**RINGSEND TO CITY
CENTRE CORE BUS
CORRIDOR**

**NTA OBSERVATIONS ON
THE PROPOSED
SCHEME SUBMISSIONS**

November 2023

Figure 2-1-3: Extract from EIAR Chapter 5

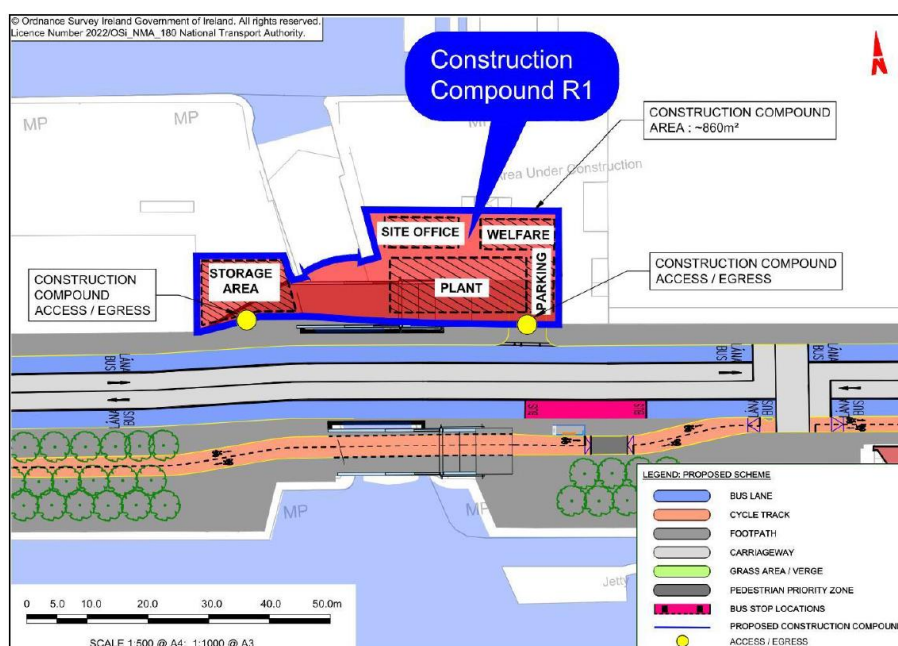
- a) Temporary CPO for the construction compound, associated noise and disruption from the compound, and the duration of the temporary acquisition.
- b) Reduced pedestrian access in 5m wide strip between the proposed compound and the CHQ building.
- c) Planning permission sought by CHQ Dublin Limited for 'Major Food Hall and Market' at CHQ Building.

The proposed construction compounds are described in EIAR Volume 2, Chapter 5 Construction, Section 5.7, which describes the full nature of the works proposed that result in the requirement to acquire the relevant lands on a temporary basis for the construction compounds. Compound R1 will have 4 parts, with the main area located on CPO Plot No.1003(4) on the plaza area on the south-eastern side of George's Dock and west of the CHQ building. Ancillary parts of the compound will be located on the western side of the northern Scherzer Bridge, and on the other side of the road on the River Liffey campshire on each side of the southern Scherzer Bridge. Images of the proposed compound that is included in the EIAR are shown in Figures 2-1-3 and 2-1-4 following.

Figure 2-1-8: Photomontage R-08 relocated northern Scherzer Bridge at George's Dock

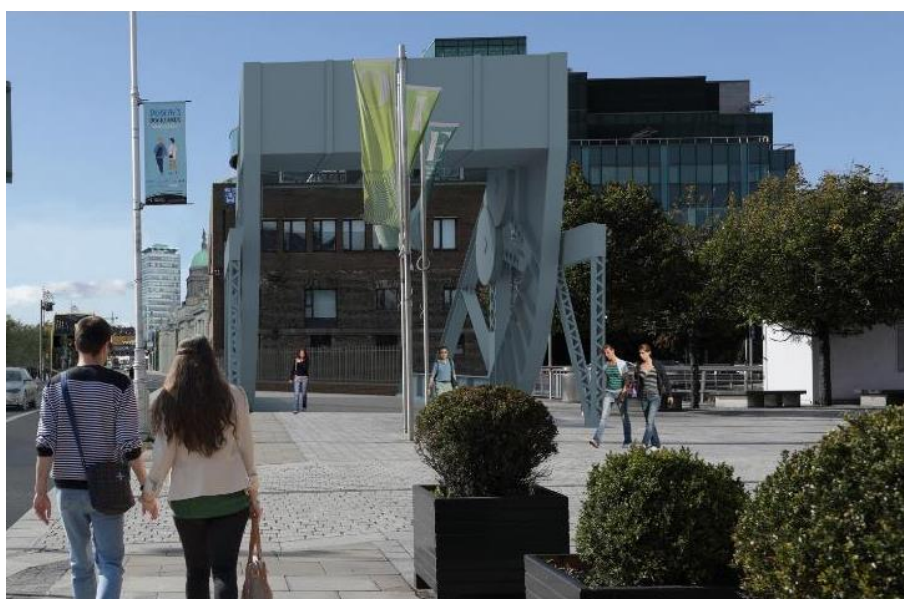
Ongoing deterioration of the historic Scherzer Bridges requires restoration works to ensure their long-term survival. These preservation works cannot be undertaken on site, and especially not while the bridges carry heavy volumes of traffic for which they were never intended. The bridges need to be carefully disassembled and removed to a workshop where they can be restored part by part under suitable sheltered conditions and then reassembled. The Proposed Scheme should therefore be seen to provide a valuable opportunity to safeguard these important heritage features for posterity. In this regard the Proposed Scheme will enable the Protected Structure status to be actively addressed, which could not otherwise happen. If these bridges were to remain in their current locations it would not be

These historic structures will benefit significantly from being relocated and restored, and their new position in the pedestrian realm will allow the general public to admire and appreciate the structures as may be seen in the EIAR Volume 3 Figures, Chapter 17 Landscape and Urban Realm, Section 17.2 Photomontages, View R-08 shown below.

Figure 2-2-5: Access Route for Deliveries to 3-Arena
(Route via North Wall Quay along red arrows / More direct route along green arrows)

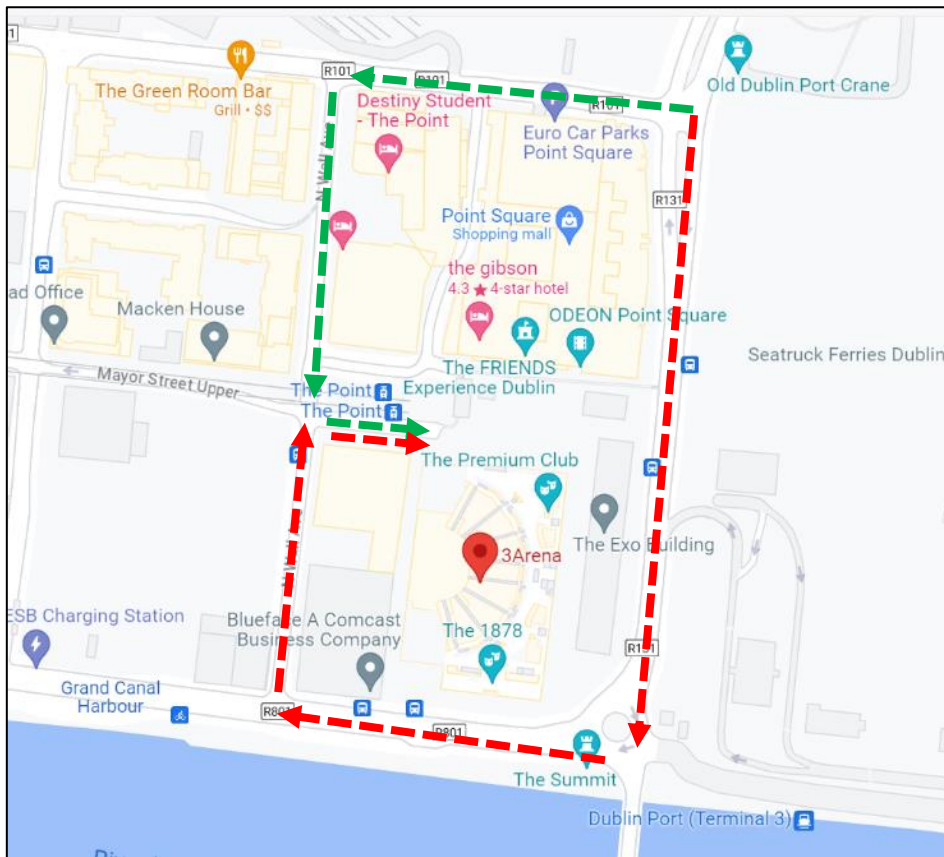
1. Access to 3-Arena small service yard at SW corner of property.
2. Maintenance of access to 3-Arena and its service yards during construction, including from North Wall Avenue.
3. Request for the CBC Contractor to consult with 3-Arena about events and access.
4. Request that Works should cease by 9pm so as not to impede people leaving events. Large numbers of pedestrians for events.
5. HGV Restricted Zone – clarify that Sherriff Street Upper and North Wall Avenue are designated HGV routes. Access for deliveries and waste collection not to be disrupted.
6. Right-turn to be retained into North Wall Avenue for deliveries.
7. Relocate bus stops away from access to 3-Arena service yard on NWQ.

4. Right turns for general traffic from North Wall Quay are generally being removed as part of the scheme (see Preferred Route Option Report for further details). Access to the 3-Arena Loading Bay on North Wall Avenue will be available via East Wall Road and Sheriff Street Upper as shown in Figure 2-2-5, which is a more detailed blowup from the wider area map in Figure 2-2-4 earlier. It should be note that there is a restriction on heavy goods vehicle traffic in much of the city area to the west and southeast of the 3-Arena, and therefore delivery vehicles will approach from the northeast via East Wall Road, in which case the route via Sherriff Street Upper is shorter than via North Wall Quay. In this regard the Proposed Scheme will have no impact for deliveries to the 3-Arena.

Figure 12.3: Local Diversion Route for Southbound Traffic on Guild Street onto North Quay

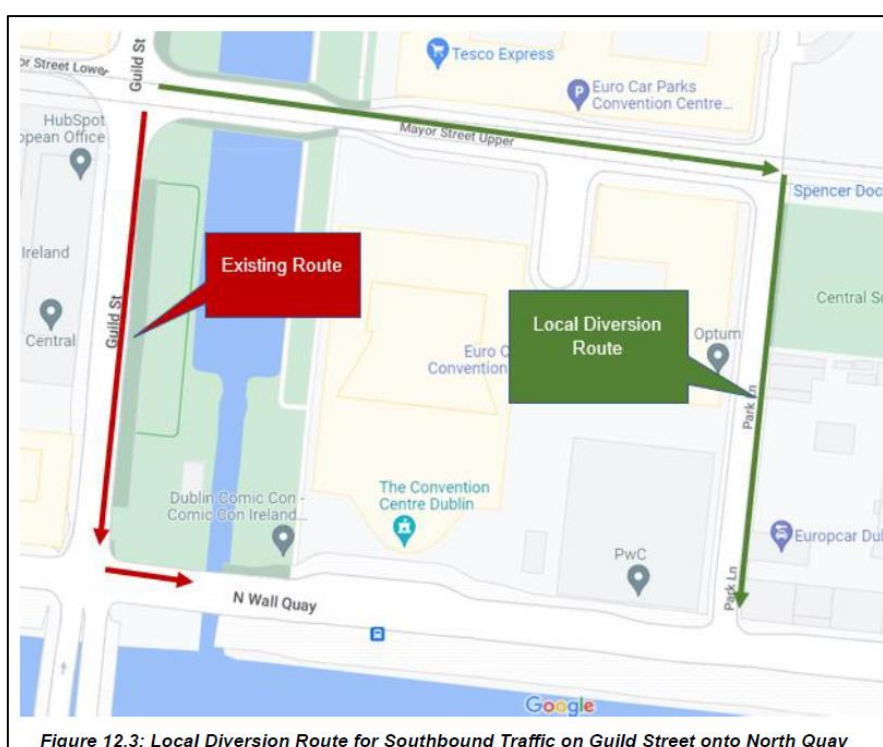
“These proposed alterations to the carriageway on Mayor Street Upper and revised traffic arrangements will interfere not only with the efficiency of the LUAS service due to degraded signal priority in both directions, but also the safety of LUAS operations due to an increase in conflicting movements.”

The proposal to remove the left turn from Guild Street to North Wall Quay will result in the displacement of a modest volume of traffic (maximum c. 40pcus / hr), which makes this manoeuvre. Most of this traffic can be accommodated via Sheriff Street Upper, however, it creates a problem for a small amount of traffic exiting from two car parks, including the Convention Centre, which must currently only exit left onto Mayor Street, and thence left only onto Guild Street. The effect of the change would therefore be to block the traffic route from the Convention Centre to Dublin Port, Dublin Airport and the Dublin Tunnel. The proposed eastbound general traffic lane to the north of the LUAS line at Mayor Street Upper will permit traffic to exit from the car parks to the right and to access North Wall Quay via Park Lane as shown in Figure 12.3 of the PDR.
